TECHNICAL BULLETIN

* Supersedes TB900-025R1, dated 5 May 2003. Revised to correct quantity of replacement parts/supplies, generator TSO approval level and temperature conversion errors, and to extend effectivity, incorporate release of Goodrich Generator Modification Service Bulletin, and add special tools.

GENERATOR COOLING MODIFICATION

Procedures in this Bulletin provide owners and operators with information pertaining to installing generator cooling scoops on the forward swashplate fairing and cooling ducts between the scoops and the starter generators. (Ref. MDHI Modification Drawing 900P5620210-101.)

**Figure 1. Swashplate Forward Fairing (P/N 900F2611300-103) Modification
(Sheet 1 of 2)**

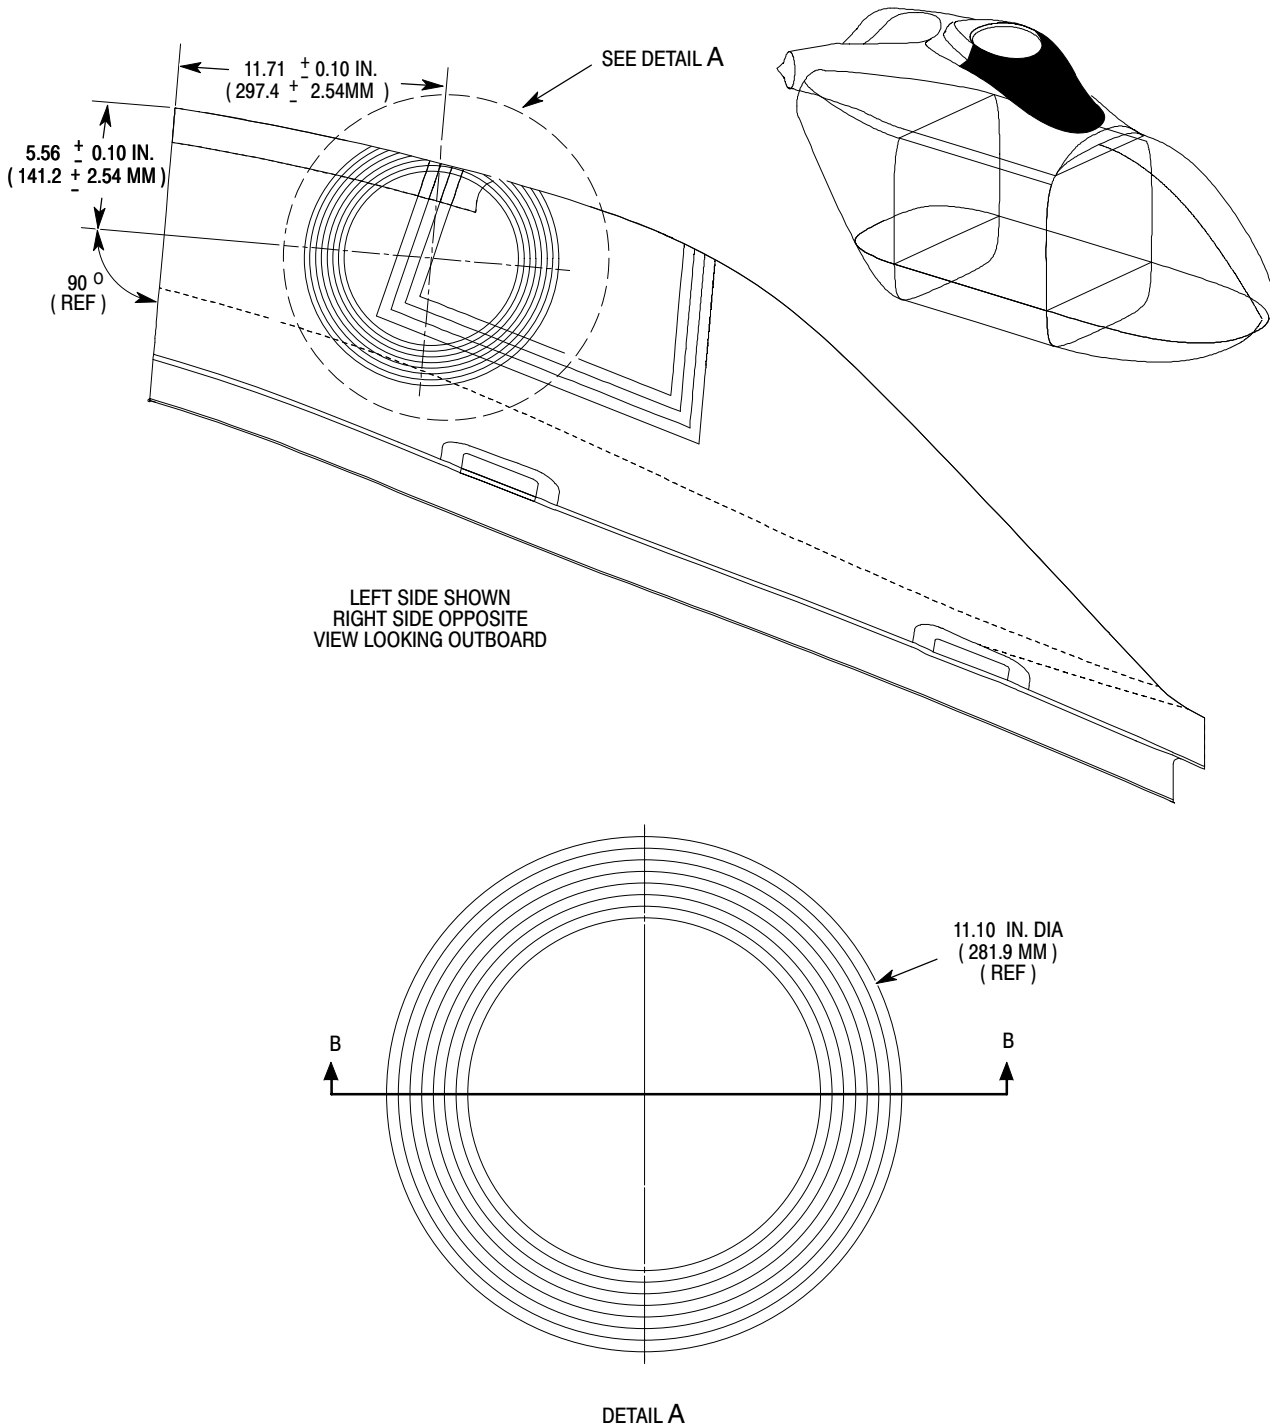
A. Modify Swashplate Forward Fairing Assembly 900F2611300-103)

- (2). Remove inner skin and honeycomb from fairing, as shown in Section B-B.
- (3). Pot area with epoxy adhesive per manufacturer's instructions.
- (4). Sand reworked area with 180 grit sandpaper.

- (5). Solvent wipe reworked area with acetone until no residue is present on clean cloth.
- (6). Cut seven pieces of carbon fabric (ply numbers -281 through -293) and one piece of glass cloth (ply number -295) to dimensions shown in Figure 1, Section B-B.
- (7). Prepare epoxy resin per manufacturer's instructions.
- (8). Wet layup each ply in order and orientation shown.
- (9). Vacuum bag and apply **20-29 in. HG (63-91 kPa)**.
- (10). Cure for 12 hours at room temperature (**80°F ± 10°F (26.6°C ± 6°C)**).

Figure 2. Swashplate Forward Fairing (P/N 900F2611350-101, -103, 900F6611350-103) Modification (Sheet 1 of 2)

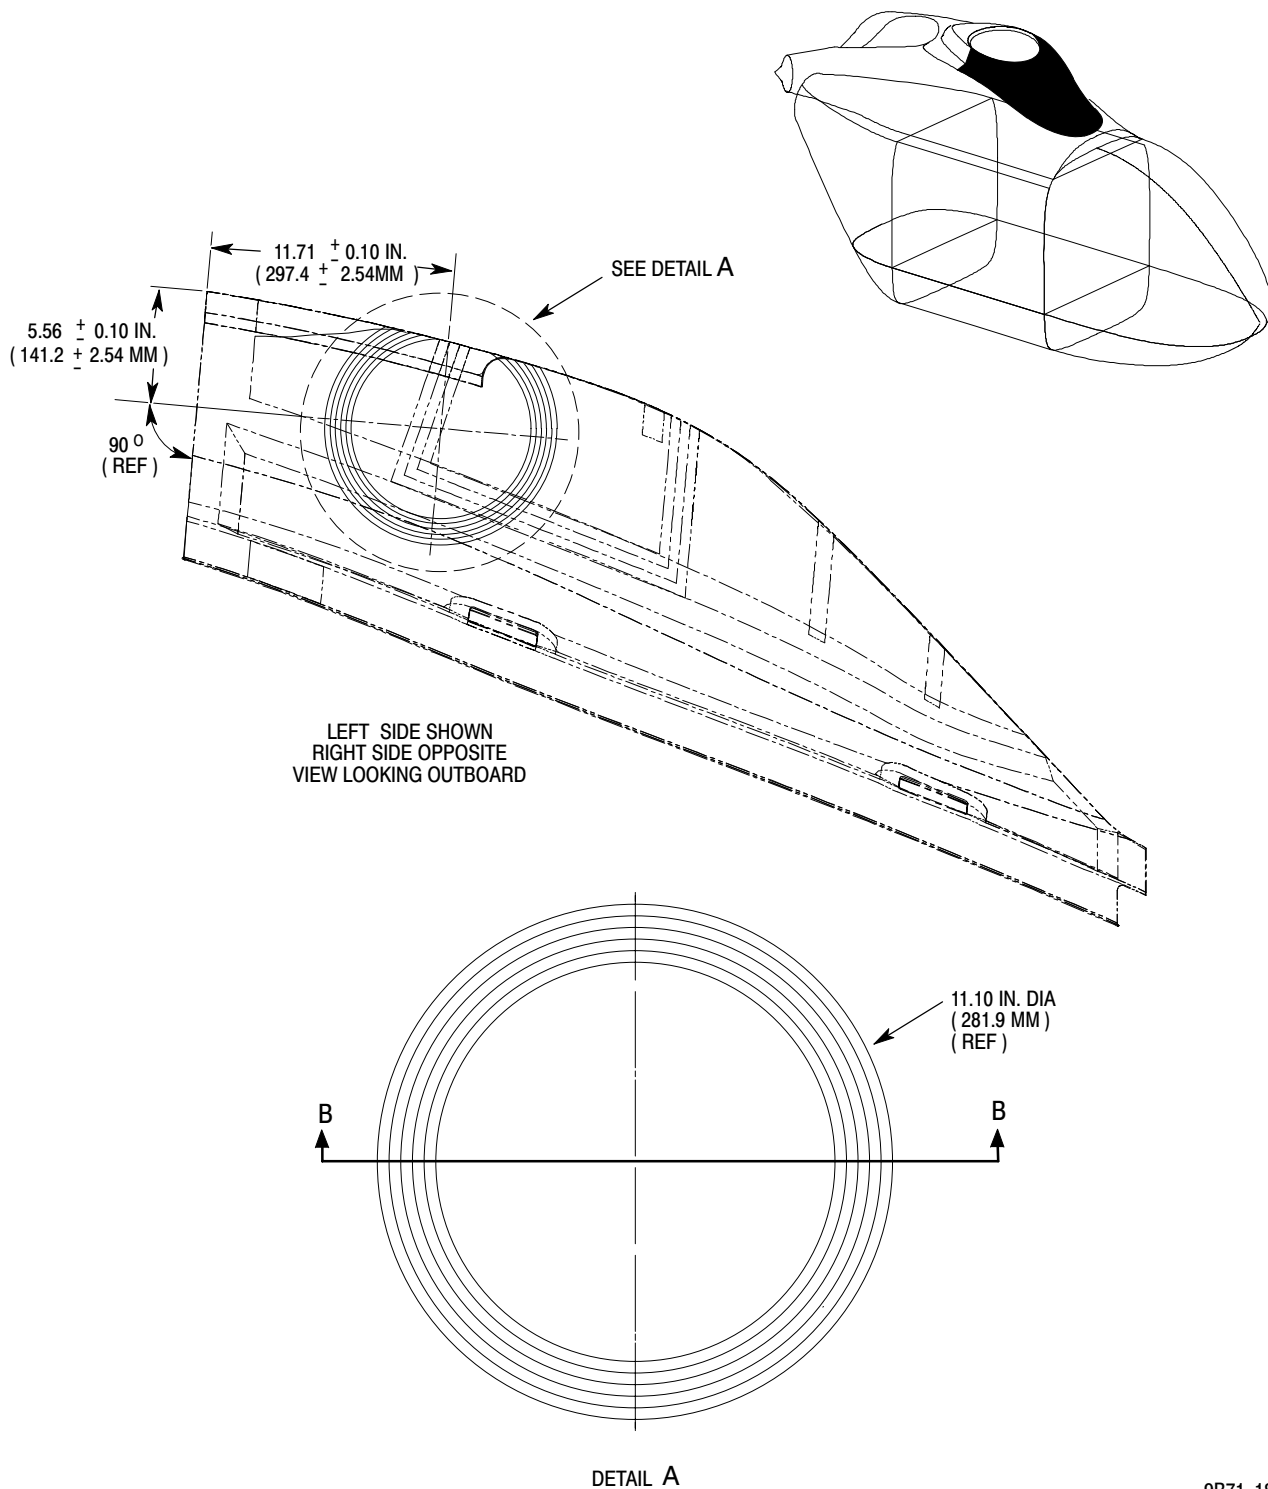
B. Modify Swashplate Forward Fairing Assembly 900F2611350-101, -103, 900F6611350-103)

(Ref. Figure 2)

- (1). Remove swashplate forward fairing (Ref. CSP-900RMM-2, Section 53-30-00, Swashplate Forward Fairing Assembly Removal).
- (2). Sand rework area with 180 grit sandpaper.
- (3). Solvent wipe rework area with acetone until no residue is present on clean cloth.
- (4). Cut five pieces of carbon fabric (ply numbers -261 through -269) and one piece of glass cloth (ply number -271) to dimensions shown in Figure 2, Section B-B.
- (5). Prepare epoxy resin per manufacturer's instructions.
- (6). Wet layup each ply in order and orientation shown.
- (7). Vacuum bag and apply **20-29 in. HG (63-91 kPa)**.
- (8). Cure for 12 hours at room temperature (**80°F ± 10°F (26.6°C ± 6°C)**).

Figure 2. Swashplate Forward Fairing (P/N 900F2611350-101, -103, 900F6611350-103) Modification (Sheet 2 of 2)

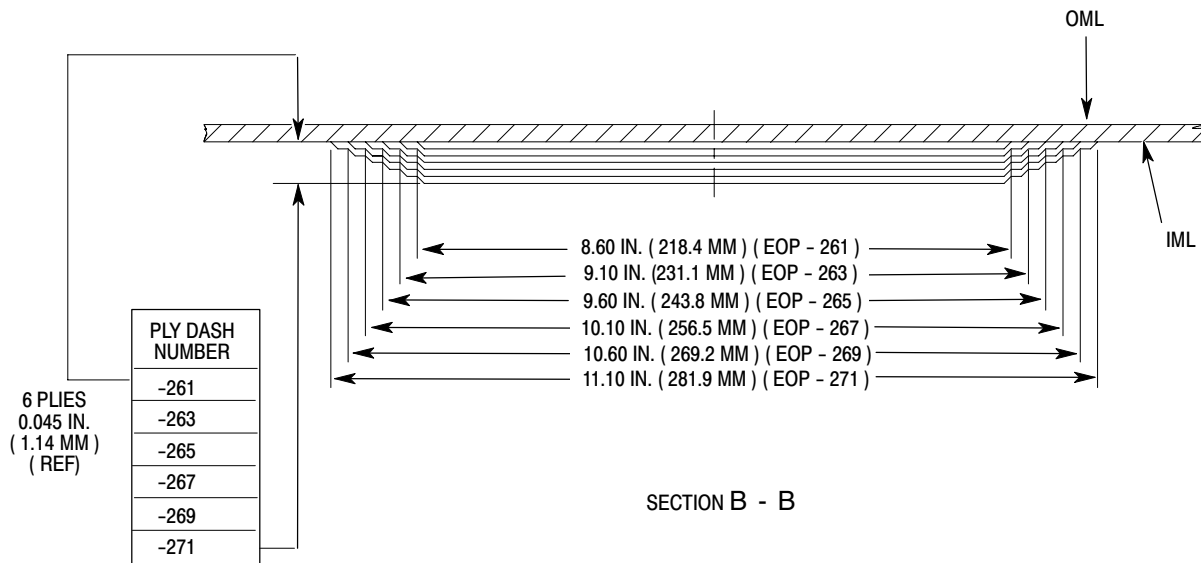
PLY DASH NUMBER	ORIENTATION
-261	±45°
-263	± 0° / 90°
-265	±45°
-267	± 0° / 90°
-269	±45°
-271	± 0° / 90°

Figure 3. Installation of Cooling Ducts (Sheet 1 of 3)

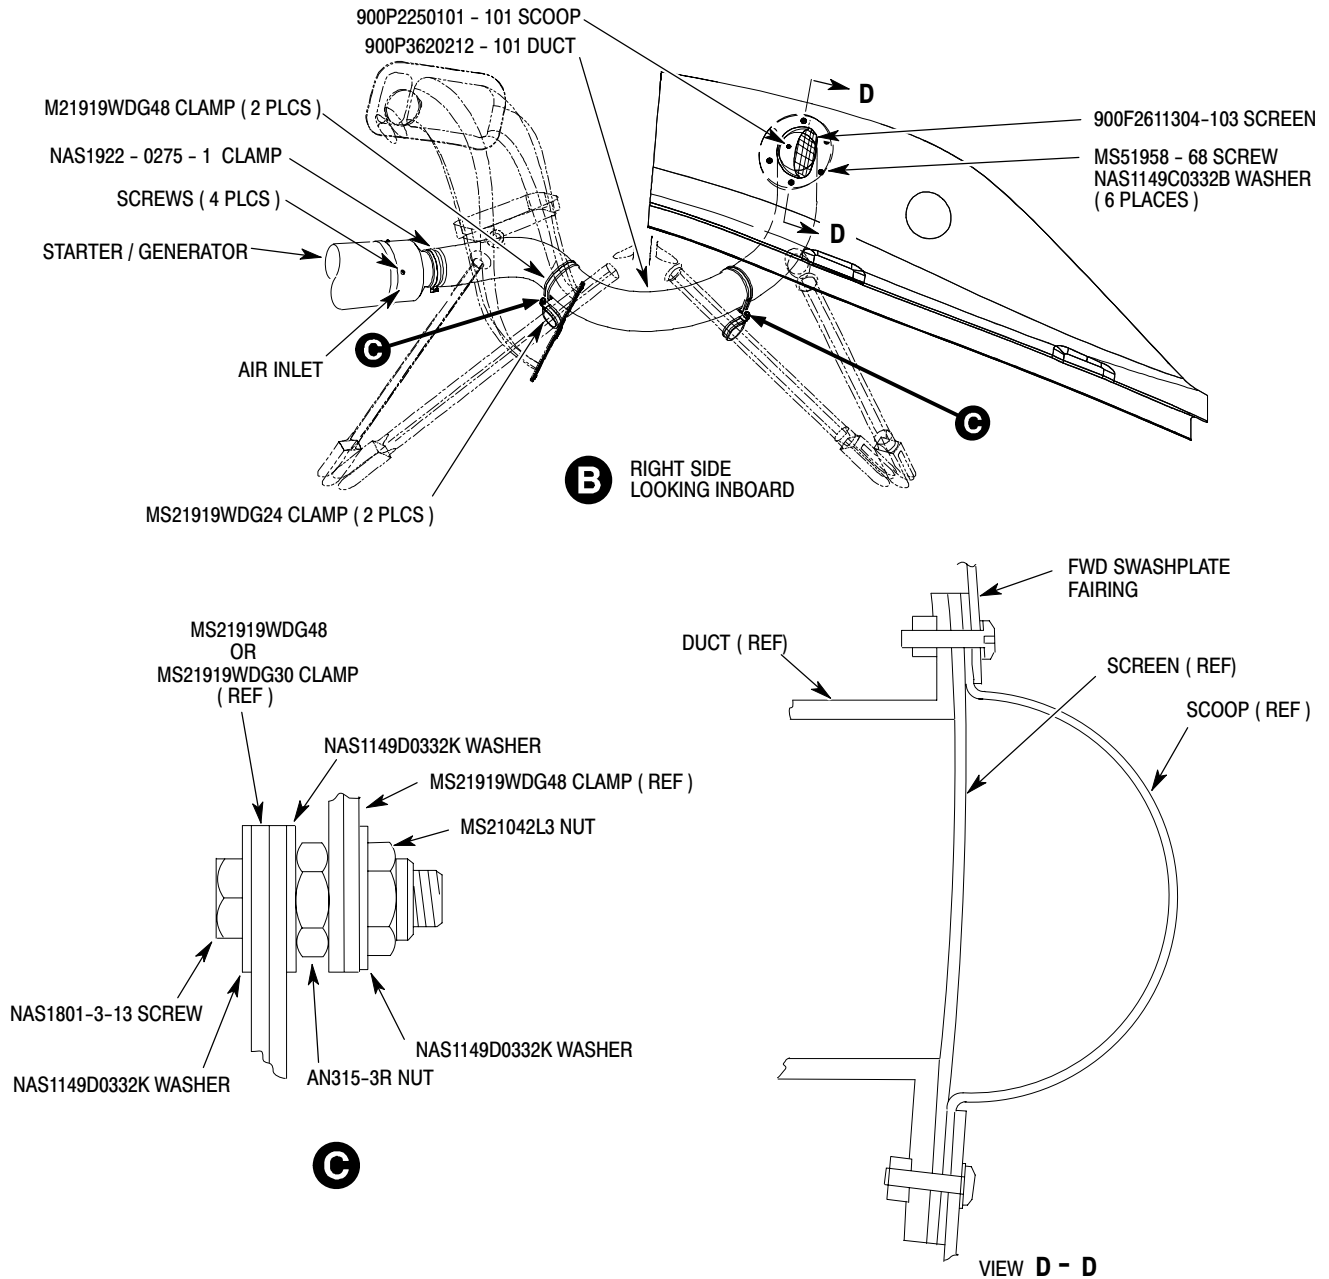
(Ref. Figure 3)

NOTE: Cutouts for cooling ducts may be located as shown in Figure 3, View E or by using scoop cutout location tools (P/N 900F2611301-107-TDF1-1 and 900F2611301-107-TDF2-1).

- (1). After layup has cured, locate and trim cooling duct cutouts on fairing.
- (2). Match drill cooling duct attachment holes in fairing.
- (3). Edge seal with adhesive/sealant.
- (4). Apply epoxy primer to reworked area.
- (5). Permanent mark modified swashplate forward fairing assemblies adjacent to part number with the following: "MODIFIED IAW MDHI TB900-025".

Figure 3 Installation of Cooling Ducts (Sheet 3 of 3)

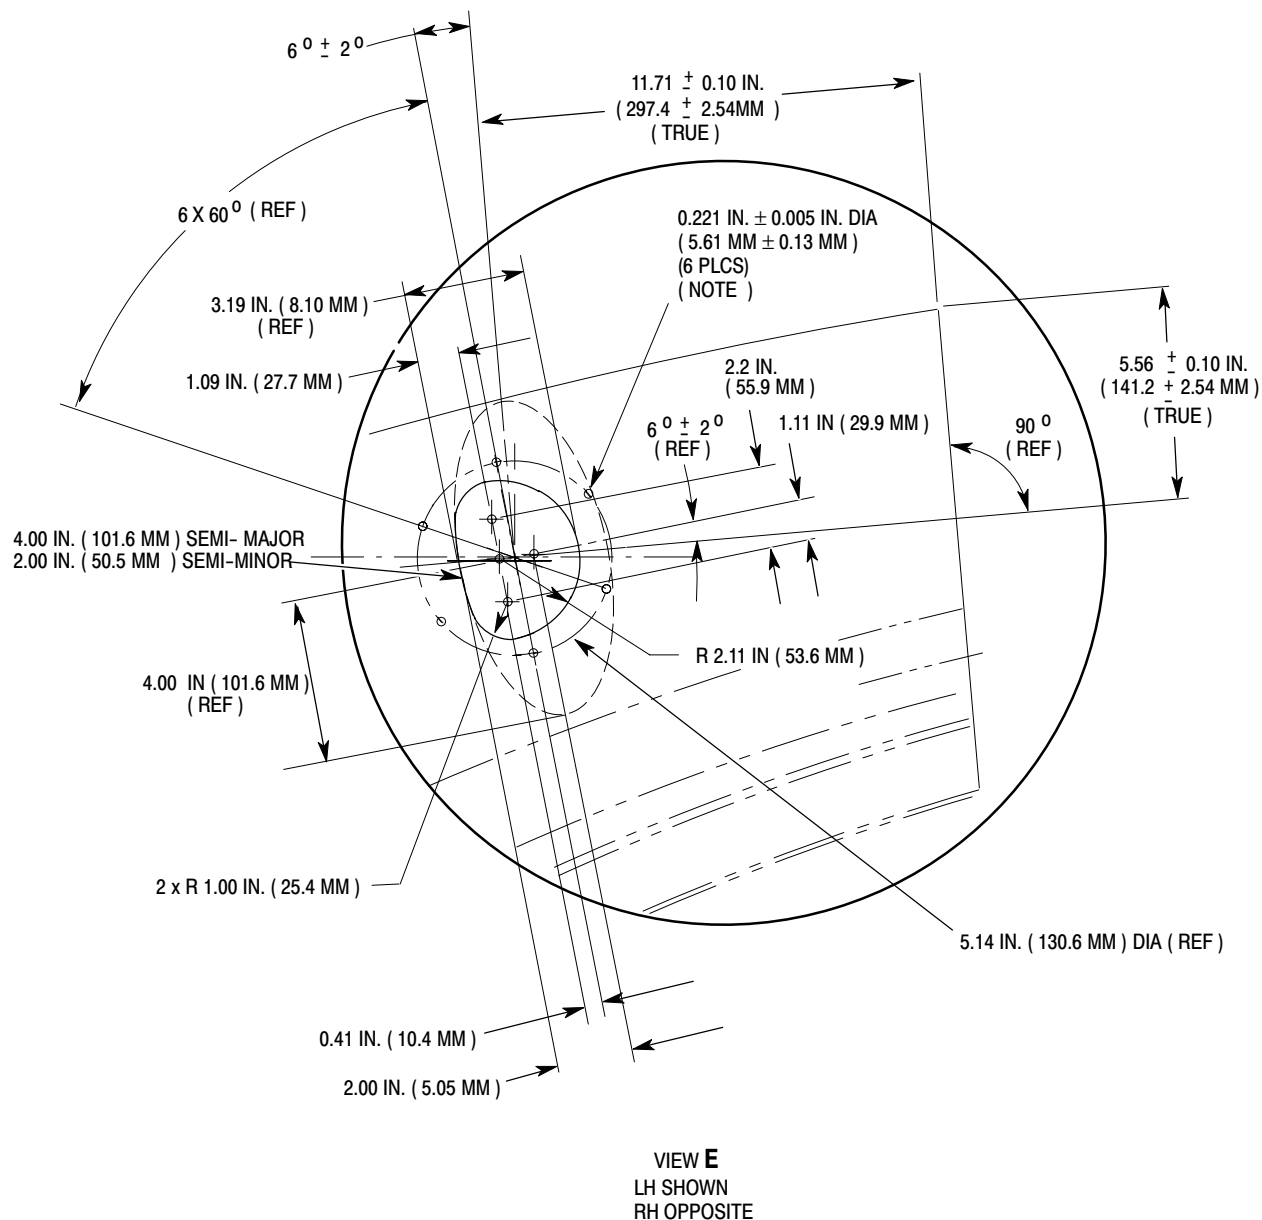
NOTE: MATCH DRILL TO GENERATOR
COOLING DUCT (P/N 900P3620212-101)
